P&Z CASE # MIS2022-019 P&Z DATE 08/30/2022 CC DATE _____ Approved/Denied

**Rockwall ISD – Updated Site Plans for Ninth Grade Center Projects:
SP 2022-17 (FM1141& Quail Run) & SP2022-18 (John King Blvd at GBCCA)**

PLANNING AND ZONING COMMISSION MEMORANDUM

DEPARTMENT	REVIEWER	DATE OF REVIEW	STATUS OF PROJECT
PLANNING	Bethany Ross	08/26/2022	Approved w/ Comments

**OVERALL
LANDSCAPE PLAN**

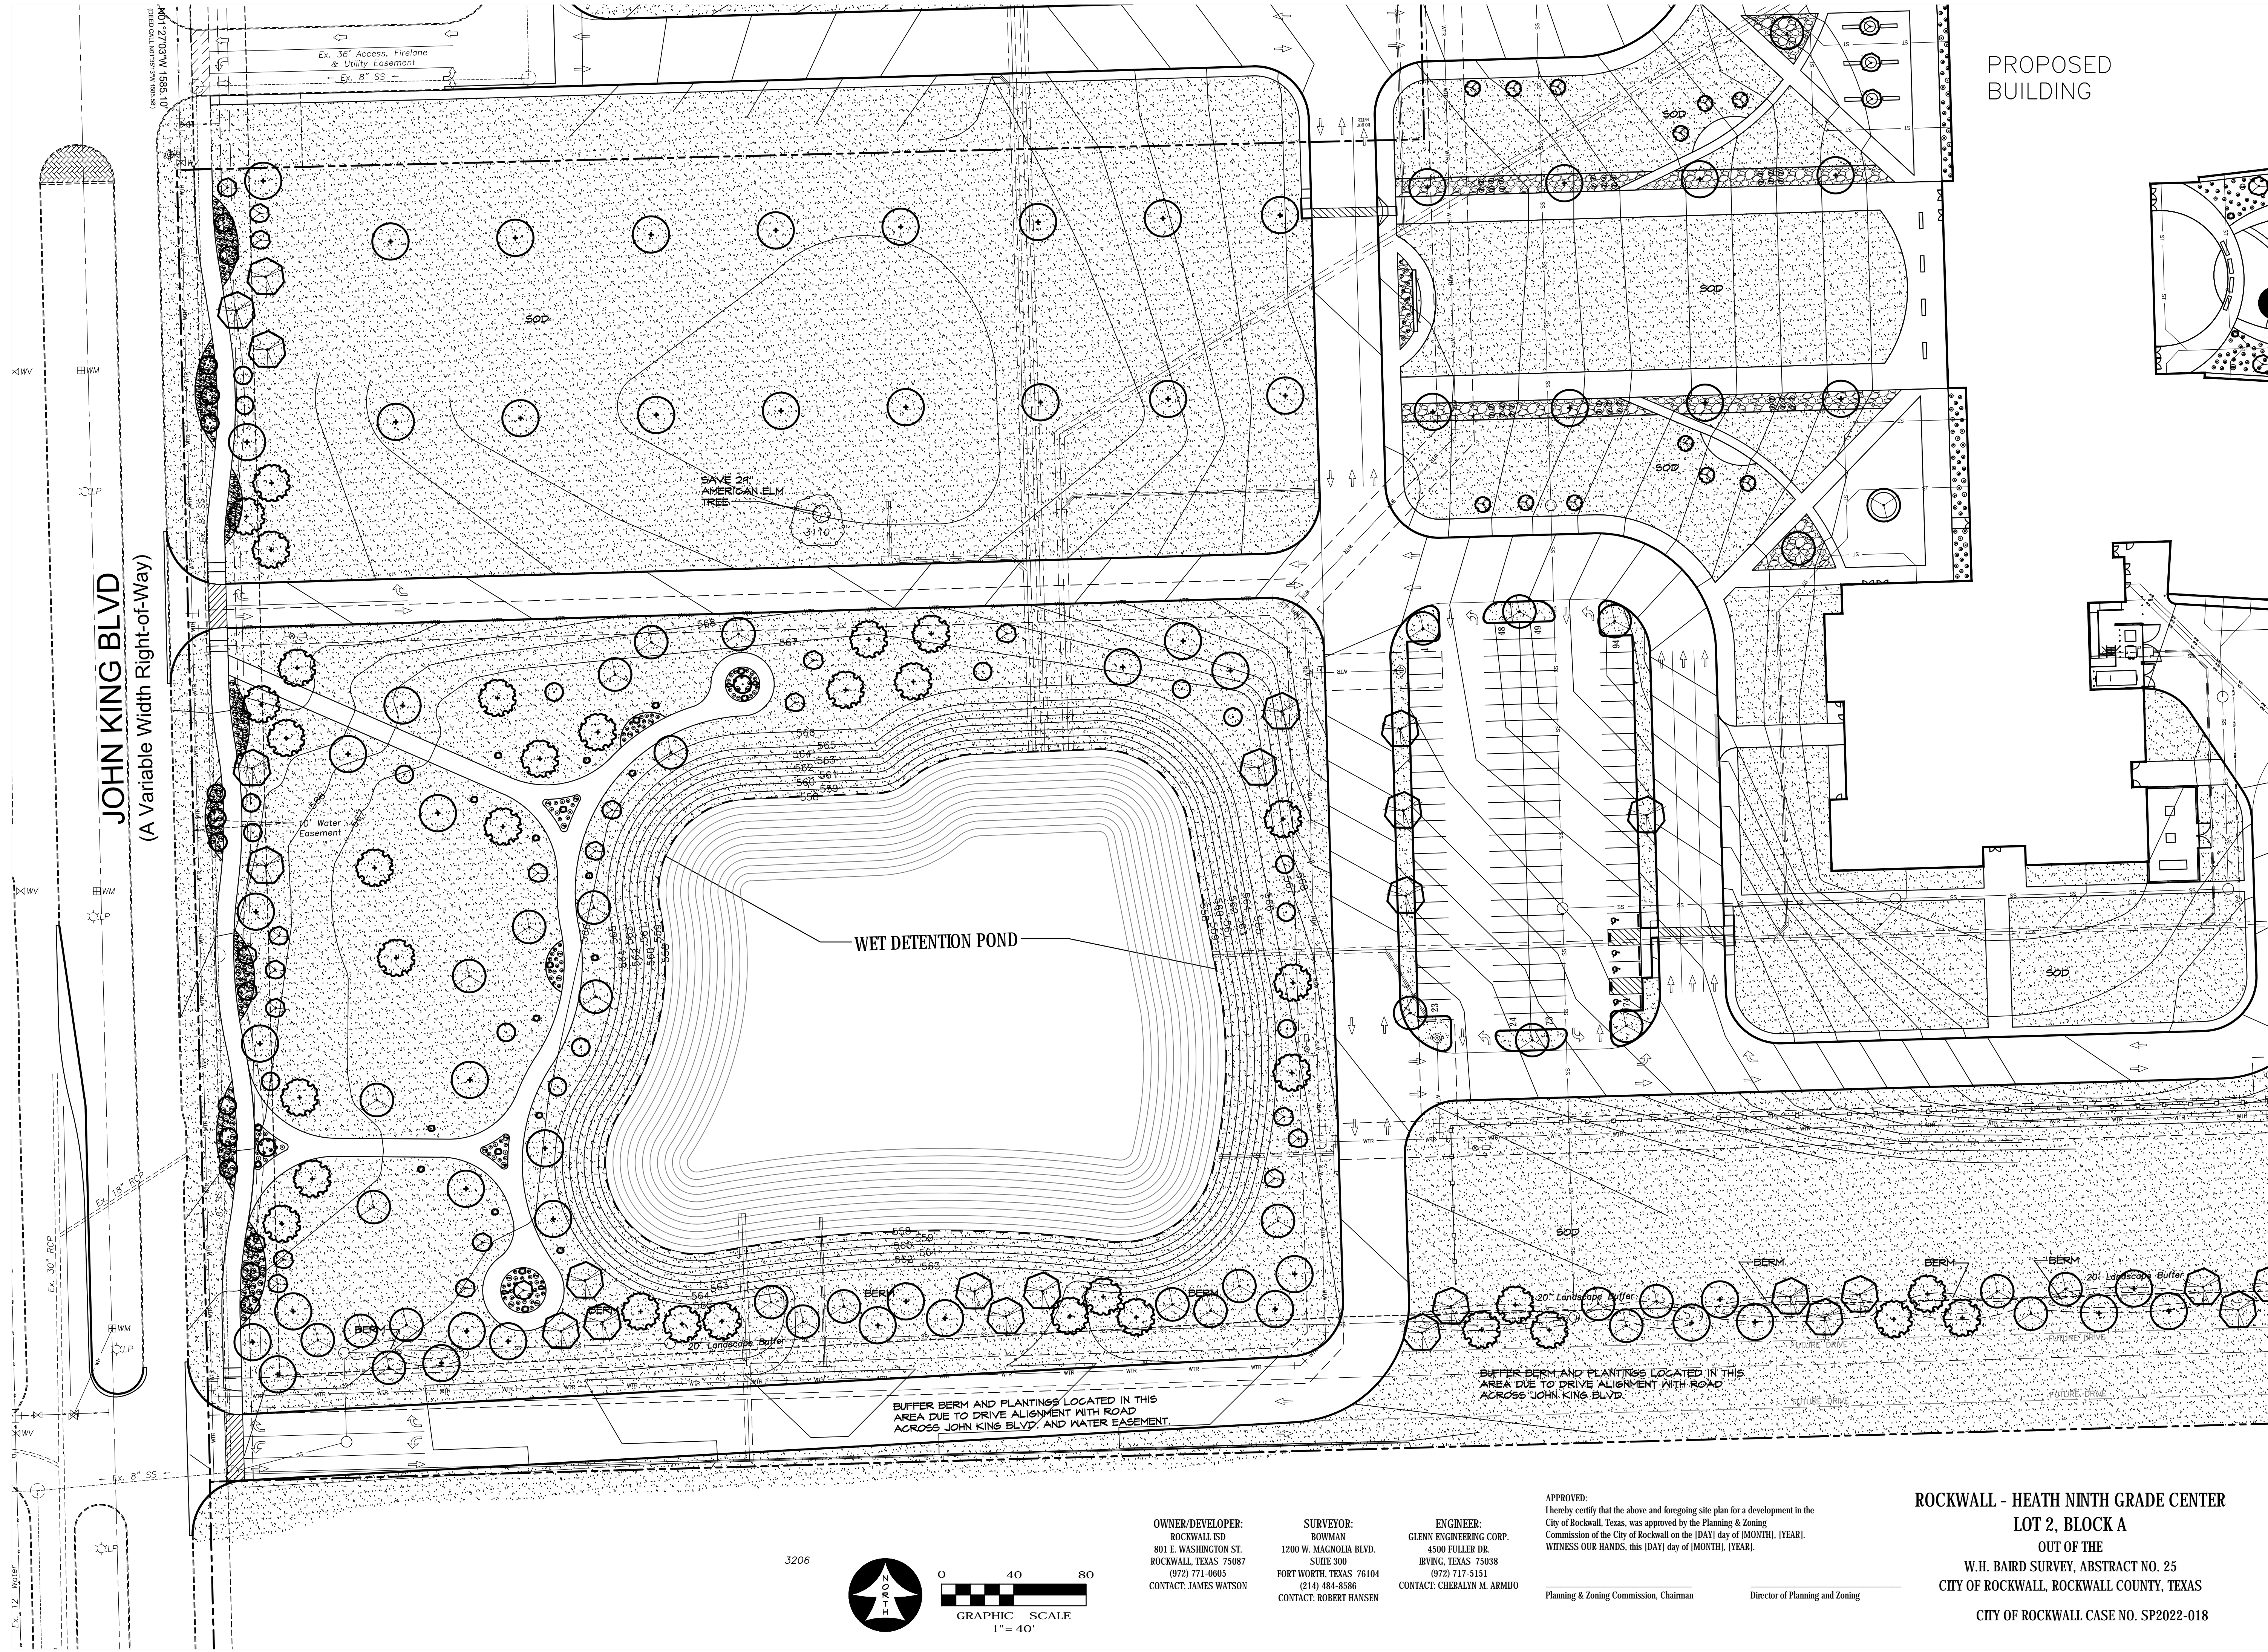
- (1) *The applicant will need to provide an updated Landscape Plan showing one (1) canopy tree per 750 SF of detention area and one (1) accent tree per 1,500 SF of detention area.*
- (2) *The applicant must request an exception for any light pole greater than 30'-0" in height per Subsection 03.03.D, of Article 07*

- (1) To omit 35% of the required trees for the detention area and disperse the remaining 65% throughout the site. The applicant has provided an alternate Landscape Plan that represents this request,
- (2) An exception to the maximum allowed foot candles within the sports fields proposed on the site. The maximum proposed illumination level represented in the provided photometric plan is 70 FC, and
- (3) An exception to the maximum light pole height within the sports fields proposed on the site. The maximum proposed light pole height represented in the provided photometric plan is 80 feet.

Rockwall ISD is submitting updated landscape plans showing the number and location of proposed trees to include in regards to the detention areas. The North plan submitted with this letter includes the required landscaping along the Panhandle Drive right of way as required.

Rockwall ISD is requesting a partial variance for consideration by the Planning & Zoning Commission. The space available around the perimeter of the detention pond is limited due to the required location on the site for these detention areas. At both sites, 3-tiered screening elements are adjacent to the detention areas limiting the amount of trees that can feasibly fit around and near the detention basin. Forcing trees in this area will create a scenario where tree canopy growth will inhibit any ground cover, reduce tree health, and increase the likelihood of erosion due to the lack of groundcover. All other required trees for the 3-tier screening and required parking lot trees are shown to be provided and we will be in compliance. As a result, the district is asking for the following variance:

Number of Required Detention Trees: (155) Number of trees proposed to be planted: (101)
Omit (36) Canopy Trees & (18) Accent Trees related to detention area requirements.
Approximate percentage of detention trees requesting to omit: (35%)

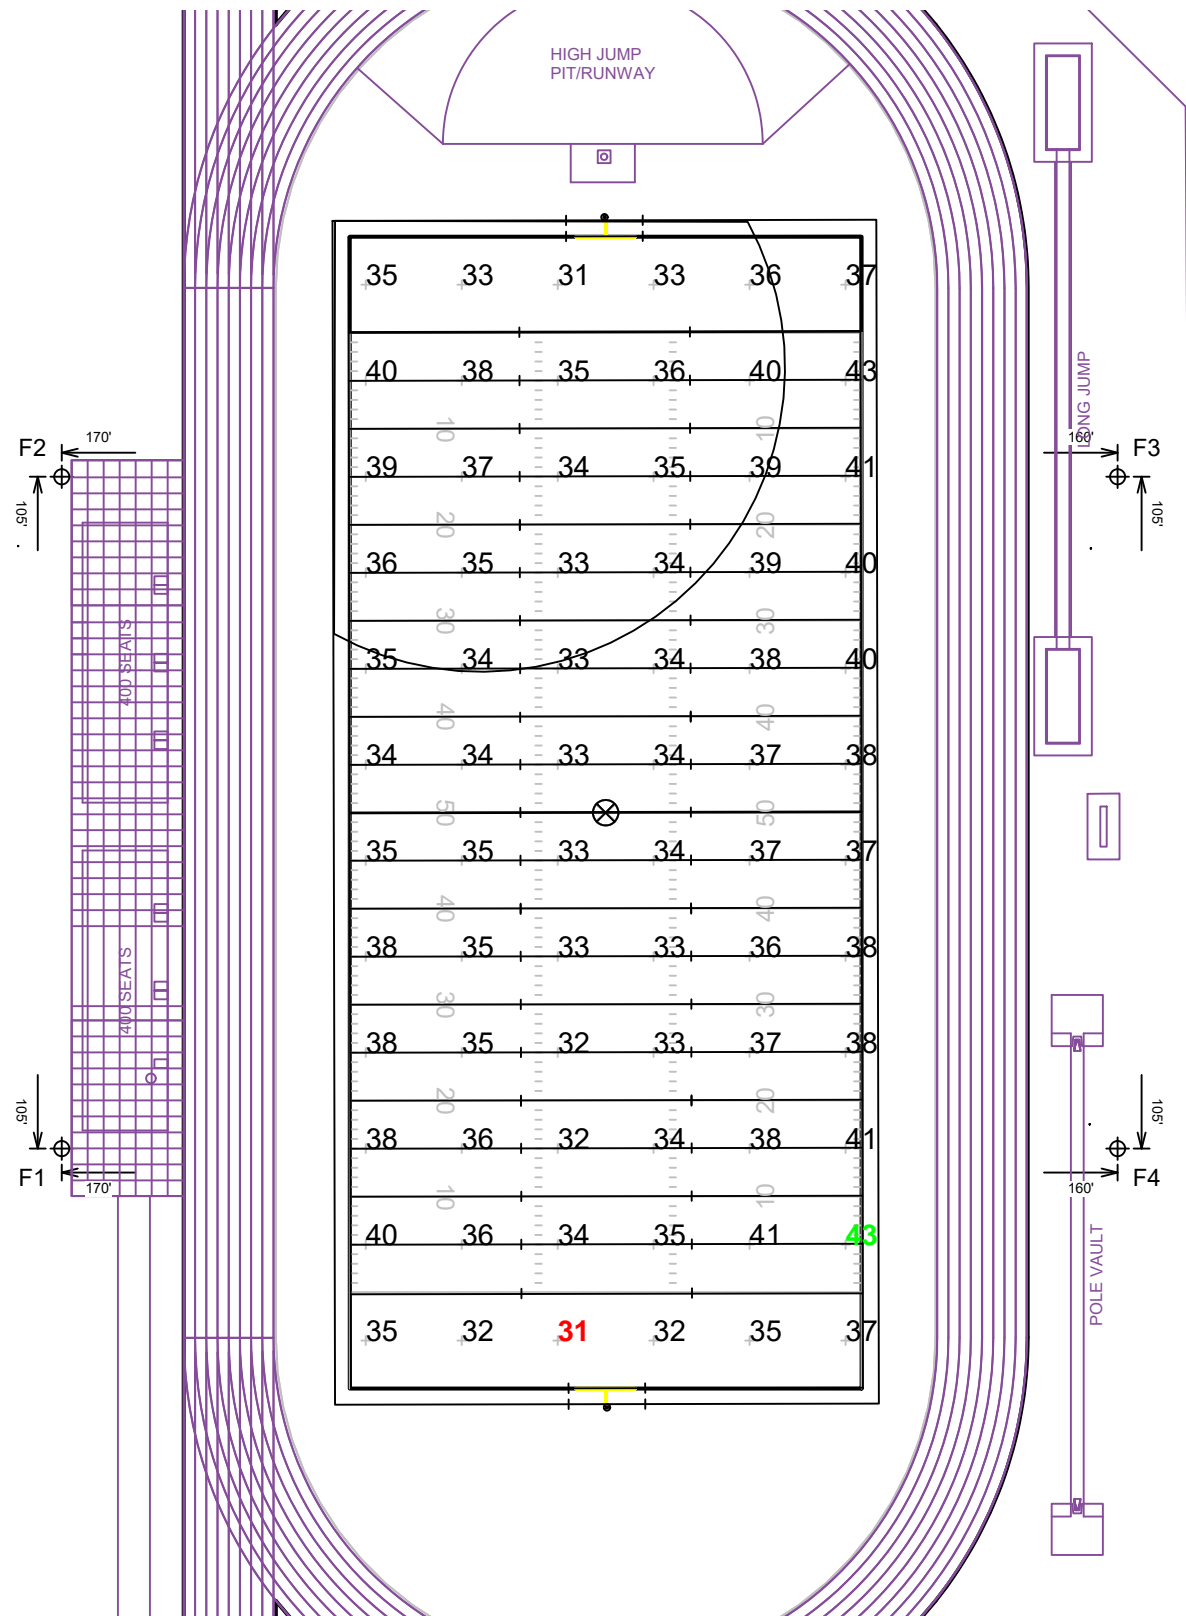
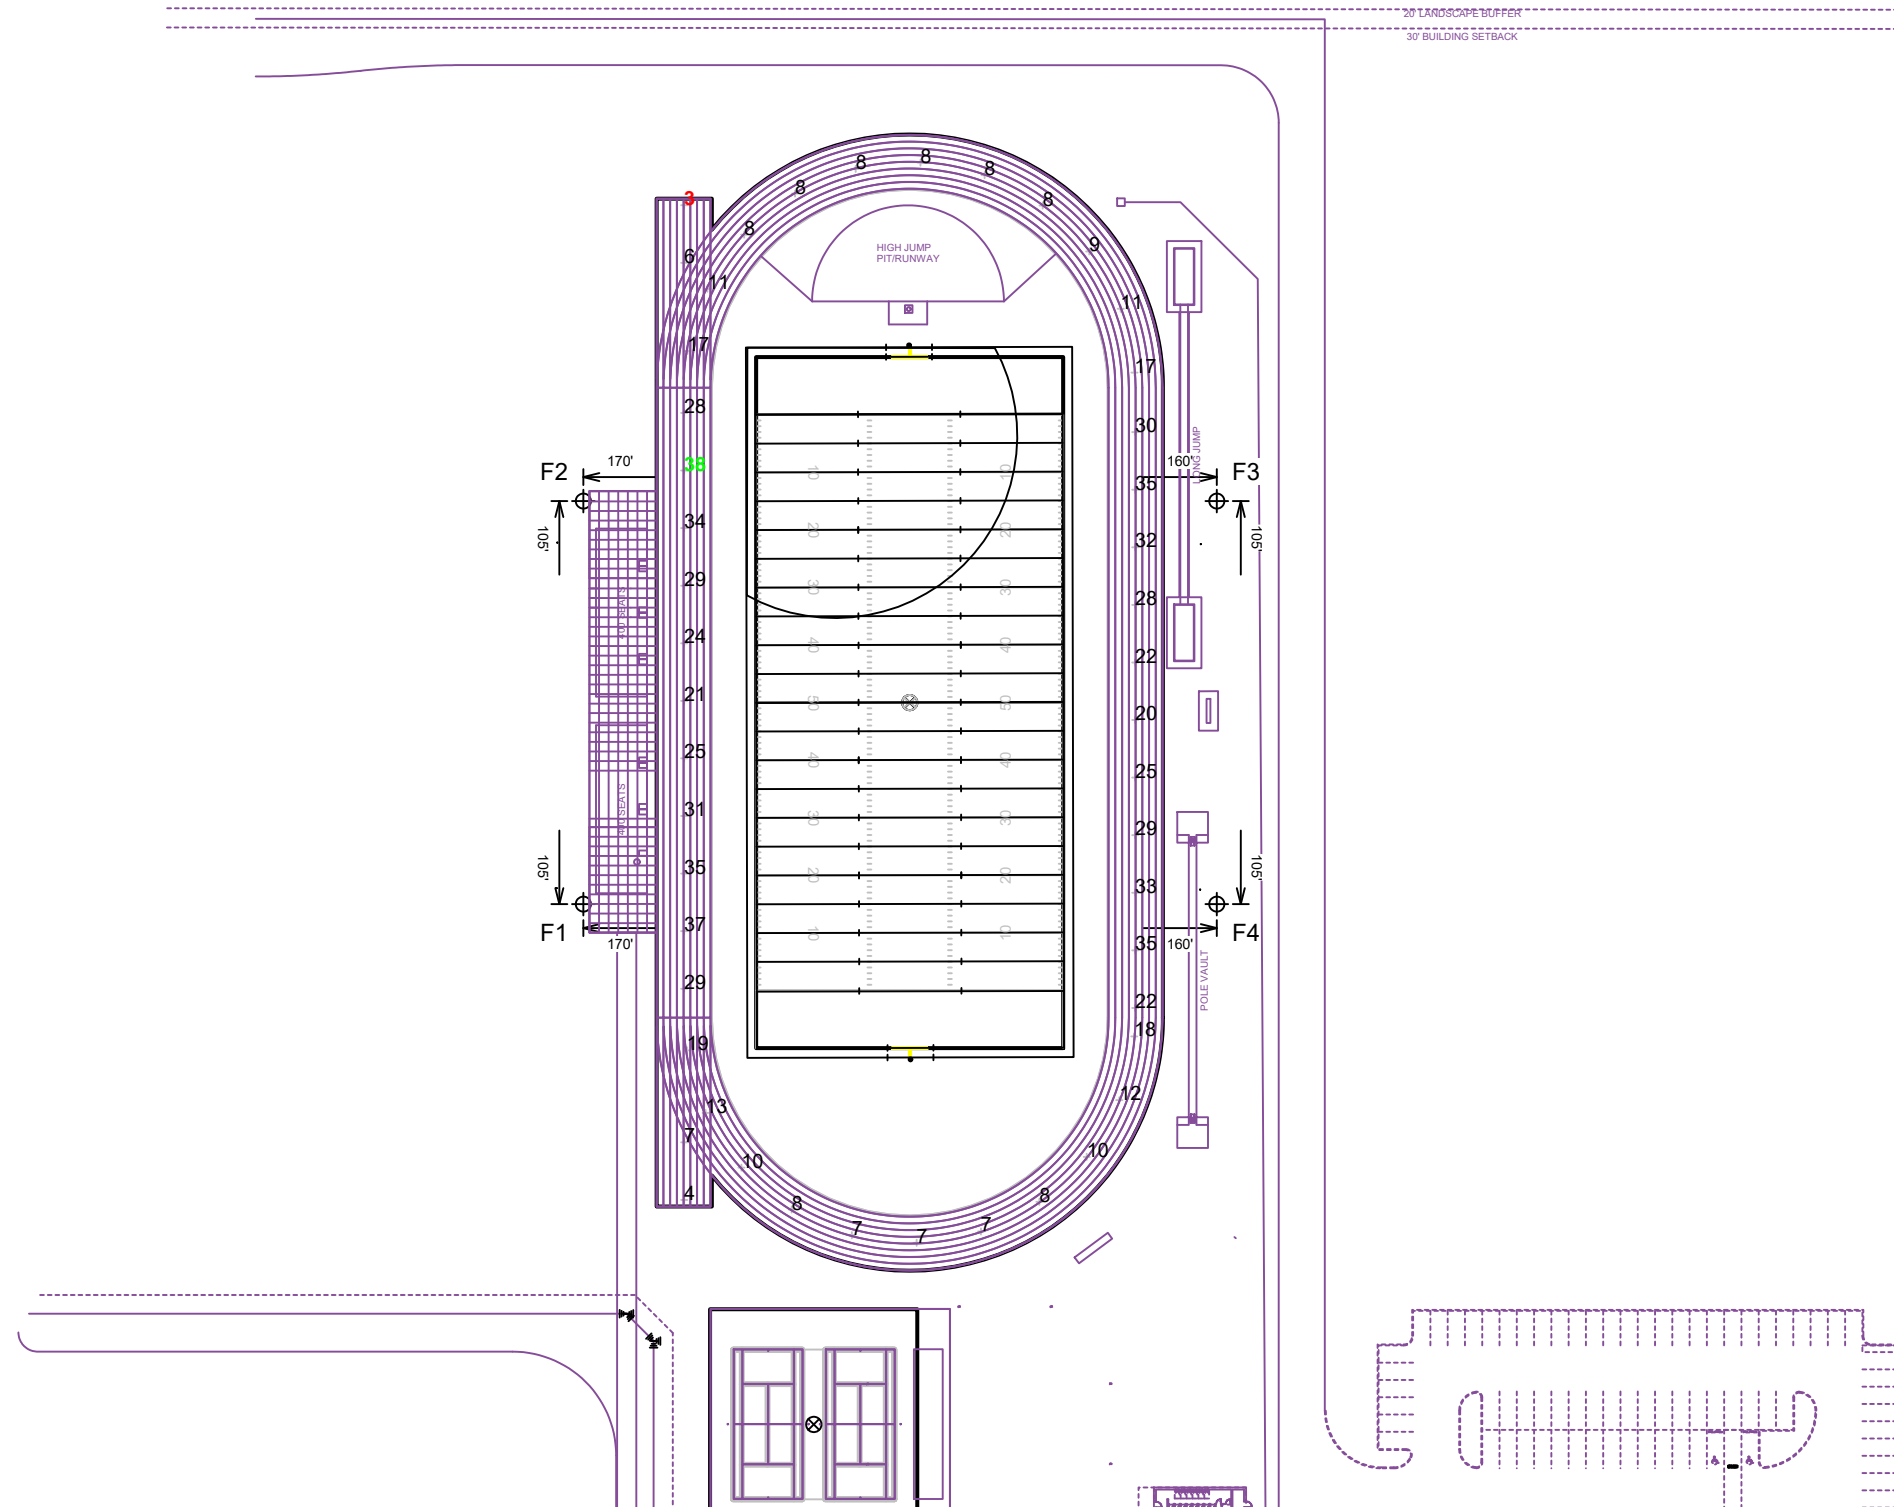
M.7 Please provide an overall photometric plan for the site. If the foot-candles located at the property line of either property exceed the allowable 0.2 foot-candles at the property line, another variance will need to be requested.

Per the above referenced comment, Rockwall ISD is requesting the following exceptions to install sports field lighting as necessary for utilization by the campus when daylight levels are not adequate for practice and game events:
